CASE COMMENT REPORT

CASE NO. UDP-S25026

CASE	UDP-S25026
PROJECT NAME	Pinnacle at Cypress / Fairfield at Cypress
APPLICATION TYPE	Site Plan Level III
APPROVAL LEVEL	PZB Approval, City Commission
REQUEST	Conditional Use for Building Height Above 8 Stories for Mixed-Use Development Containing 196 Affordable Multifamily Units, 6,525 Square-Foot Office Use, and Request for Alternate Design Solutions to the Uptown Master Plan in the Uptown Project Area
APPLICANT	Poliakoff, Becker, & Streitfeld, LLP
AGENT	Tim Wheat, Pinnacle
PROPERTY ADDRESS	6250 N. Andrews Avenue
ABBREVIATED LEGAL DESCRIPTION	Pine Crest Isles 63-48B
ZONING DISTRICT	Uptown Urban Village – Northeast (UUV-NE)
LAND USE	Uptown Urban Village Transit Oriented Development
COMMISSION DISTRICT	1 – John Herbst
NEIGHBORHOOD ASSOCIATION	N/A
SUBMITTED	June 18, 2025
COMPLETENESS ISSUED	June 27, 2025
STATE STATUTE 166.033 EXPIRATION	December 24, 2025 (180 Days)
CASE PLANNER	Jim Hetzel, AICP Principal Urban Planner

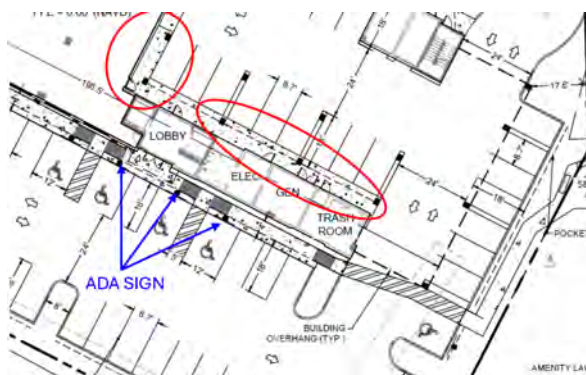
16. ULDR, Section 47-37B.5, Table of Dimensional Requirements, provide a breakdown on residential unit sizes in square feet in the site data table.
17. ULDR, Section 47-37B.6.B, Open Space, staff is unable to determine if the project fully meets open space based on the following items identified as open space. Note, the areas as open space must meet the definition of open space and plazas.

- a. There are areas hatched that are sidewalks/walkways along the building;
- b. Landscape median area;
- c. Building entrance with ramp and stairs;
- d. Indicate location of private amenity area(s) for both phases;
- e. Existing plus phase 1 does not meet the minimum of 22,500 square feet of pocket park space, existing plus phase 1 and 2 does meet the minimum. Applicant needs to clarify phasing and the open space area attached to phase 1 and 2;
- f. Use of the ROW area is subject to finalization of transfer of ownership to the applicant;
- g. Provide the square feet of the ROW area being used for open space; and
- h. The north parcel requirements cannot be modified by reducing the plaza calculations down from 3,000 square feet to 1,000 and counting that area for pocket park.

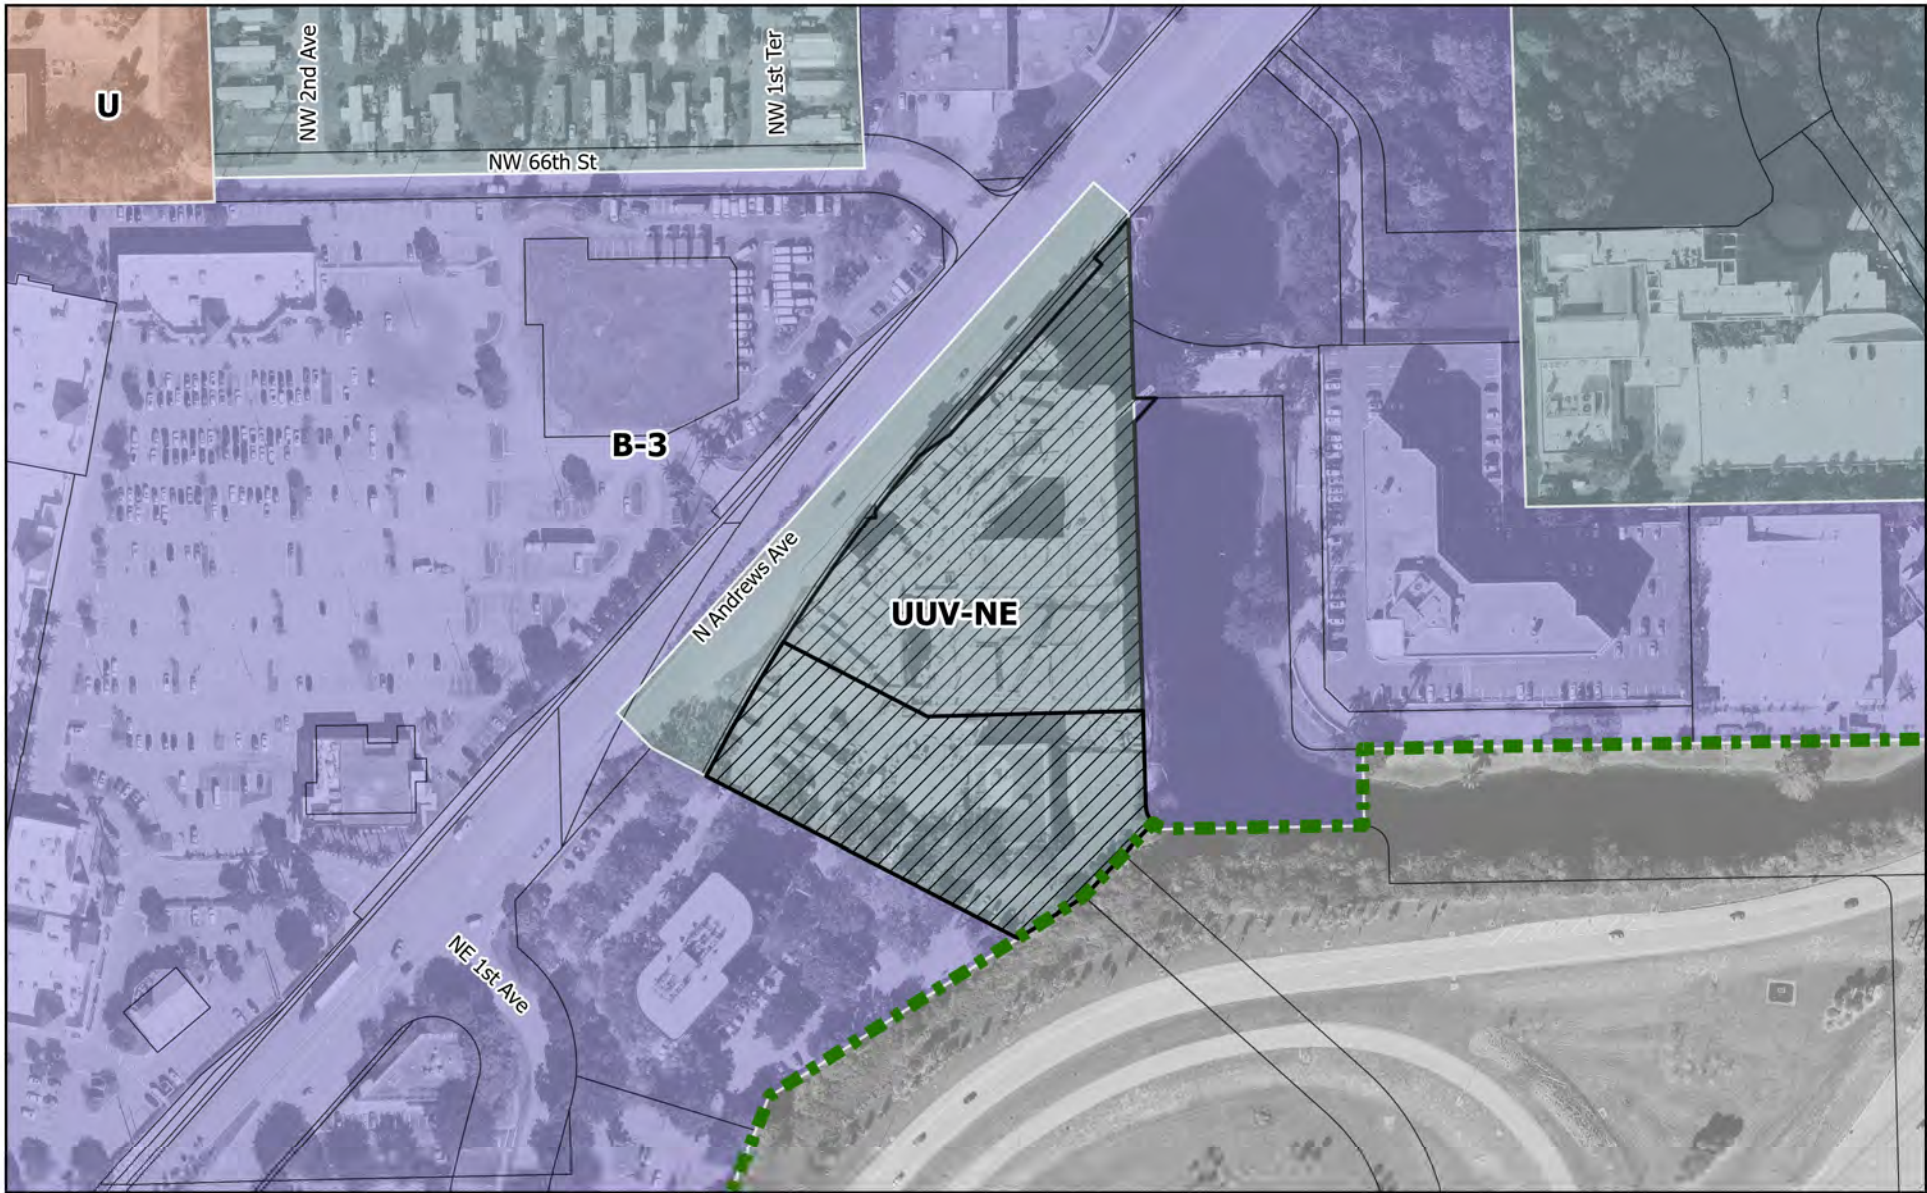
- 18. The property contains a ten-foot FPL easement where there are improvements and structures proposed which is not permitted. Provide information on how the applicant plans on addressing the easement conflict. Note, vacation of easements are separate application and process.
- 19. Provide a vehicular and truck movement plan that shows movement in and out of the parking garage area, collection of refuse, and overall turning movements for the site.
- 20. Provide the following changes on the site plan:
 - a. Indicate dimensions for all drive aisles;
 - b. Label all site features and elements including seating areas;
 - c. Provide a direct pedestrian walkway leading to the residential entrance – see image below.

- d. There are several pinch points with doors and columns that need dimensions indicated on plans – see image below.
- e. ADA parking must be directly accessible to building entrances. The ADA parking located farthest east on the site does not meet this requirement. In addition, the ADA pole location is within the parking space depth. See image below.
